Strathcona Gardens Rec-Reate Aquatic Centre & Renovations **ADDENDUM #4**

Date: March 28, 2024

ARCHITECTURAL TENDER ADDENDUM #4

This addendum revises the Tender Documents for Strathcona Gardens REC-REATE issued for tender February 2, 2024.

A203

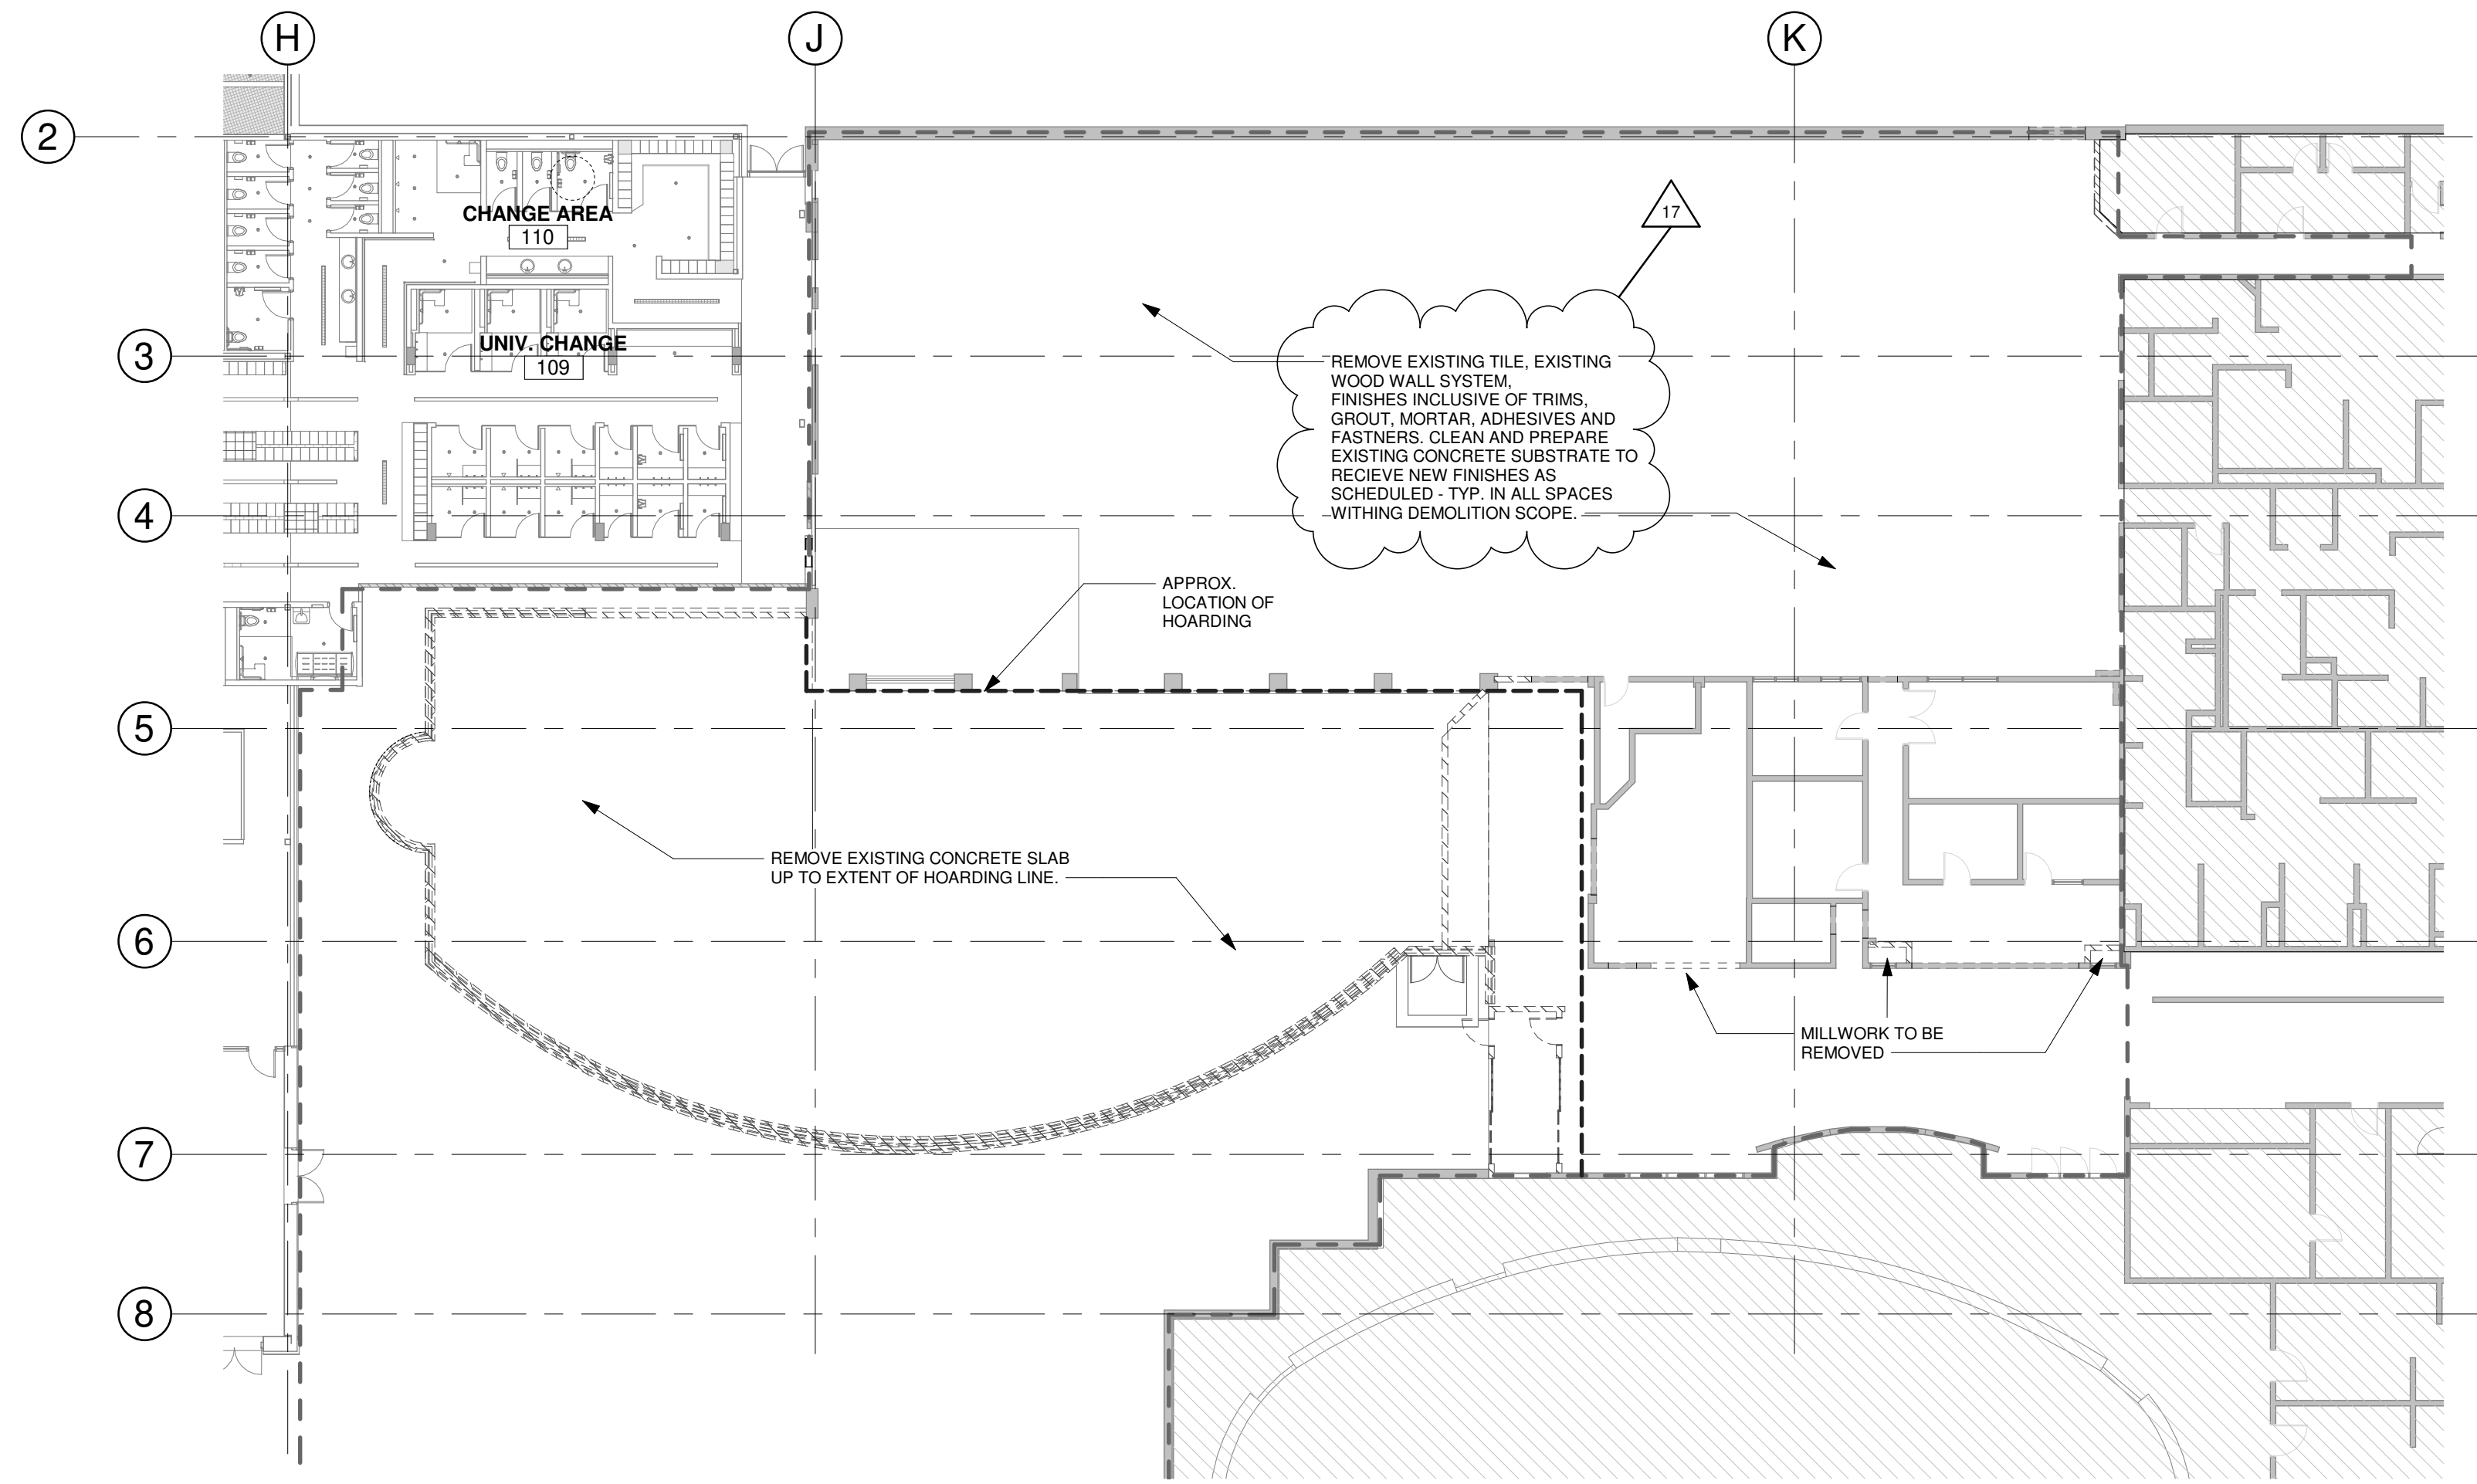
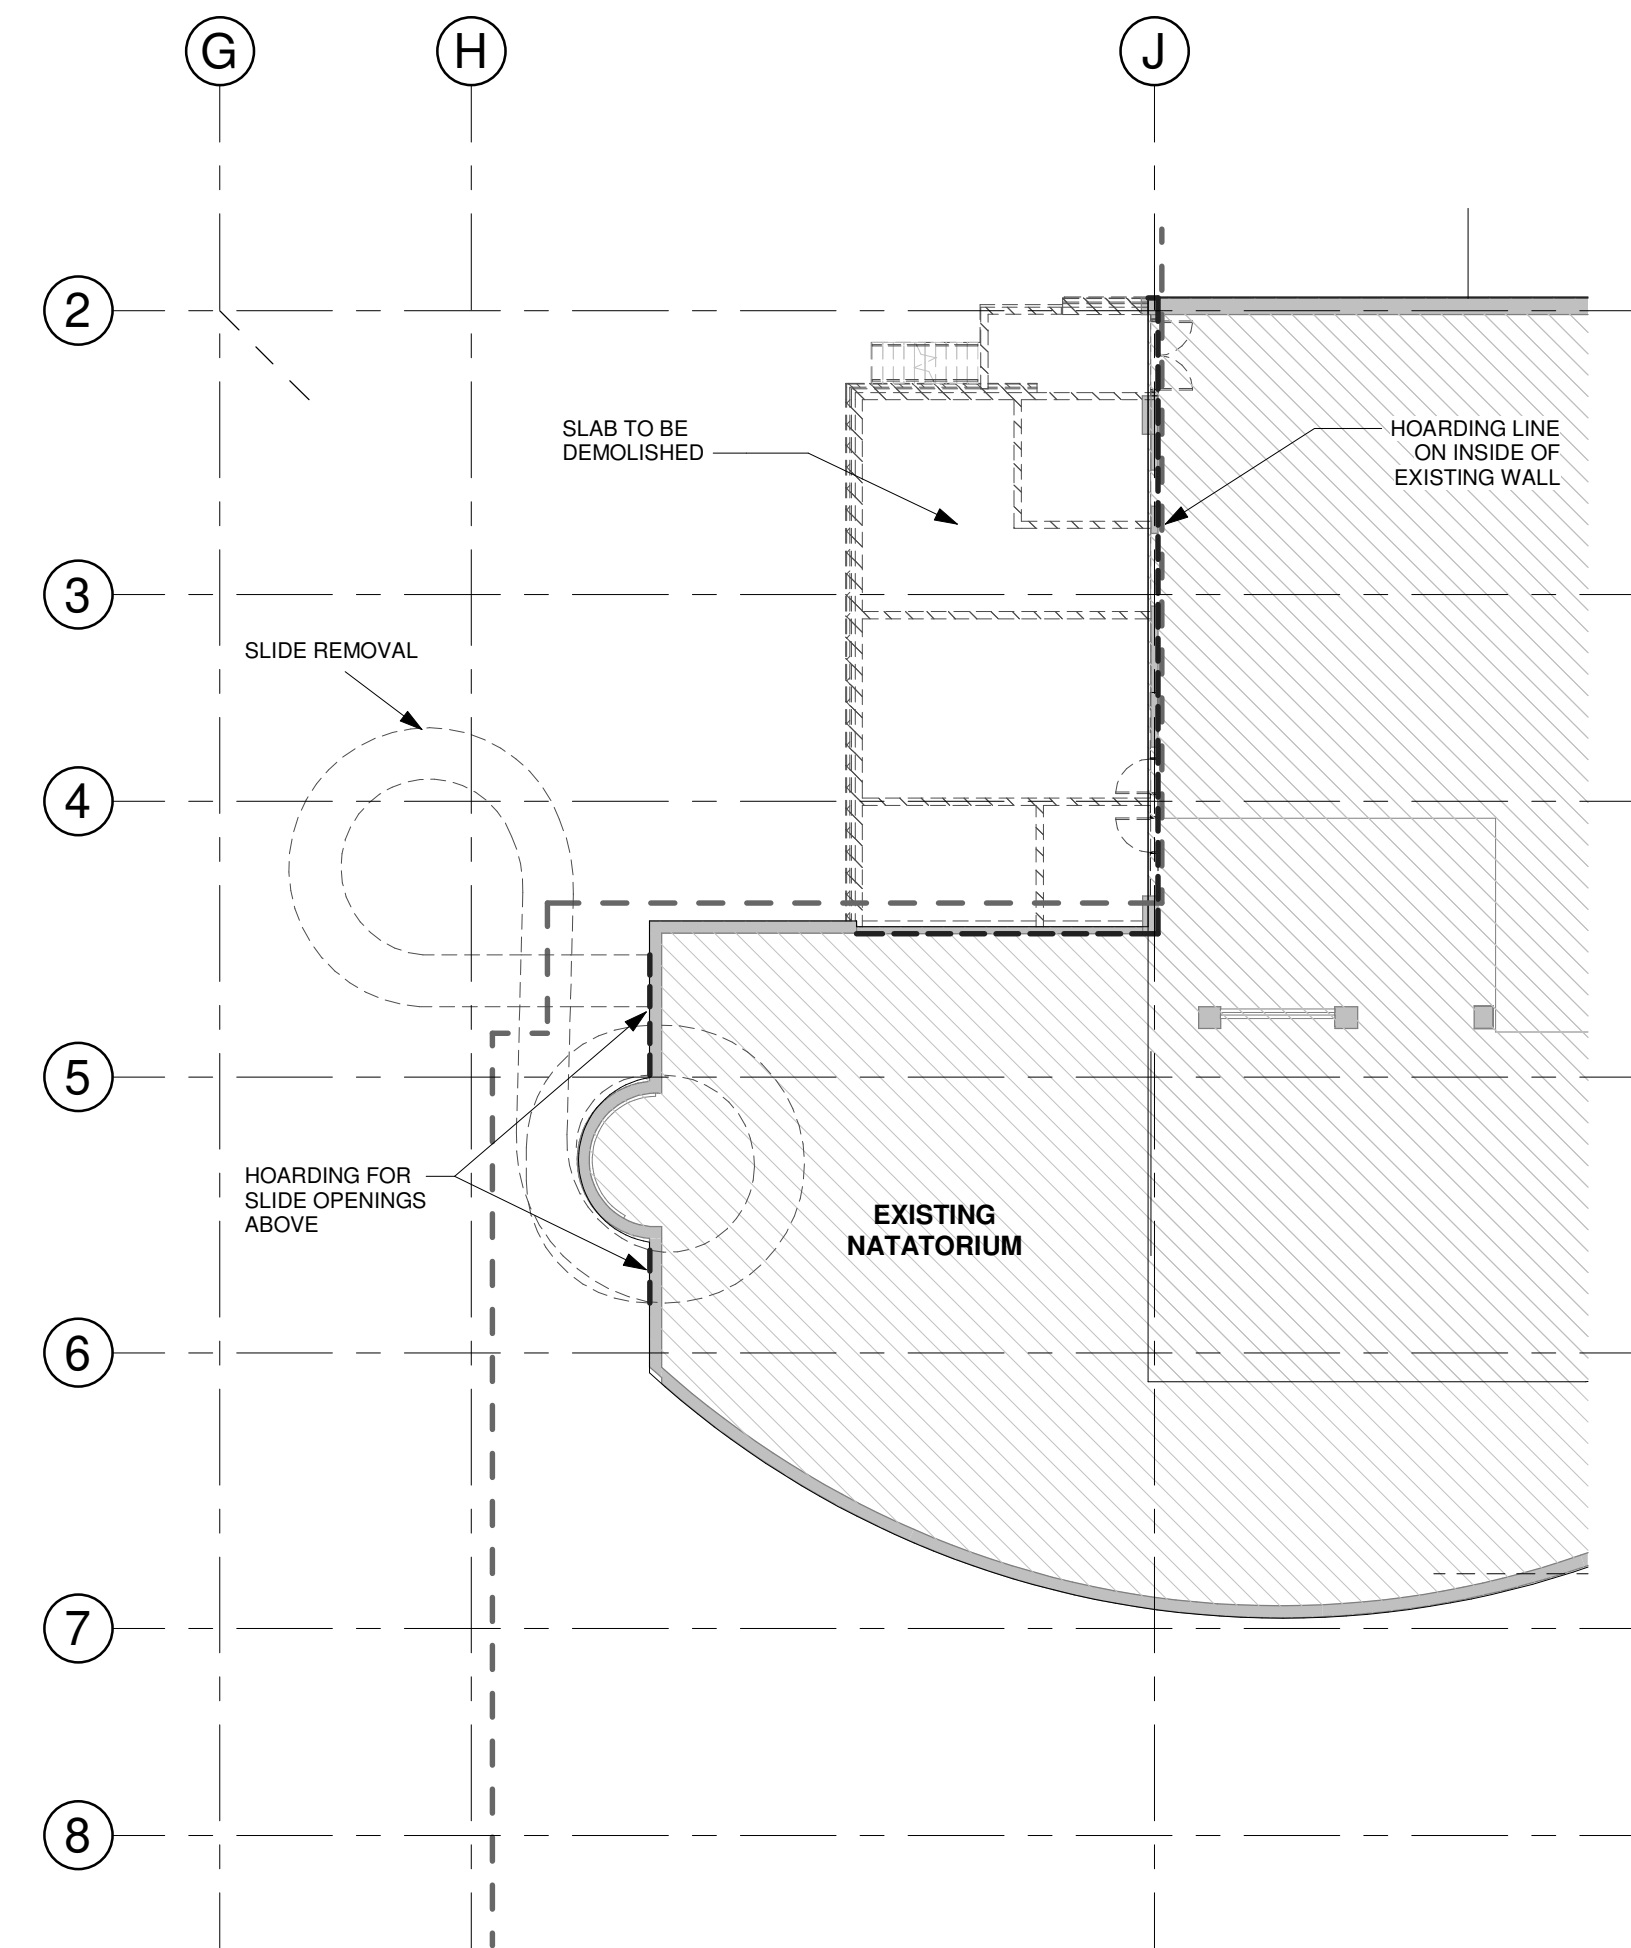
1. REVISE: A203/2 demolition note to include the removal of the existing wood wall system.
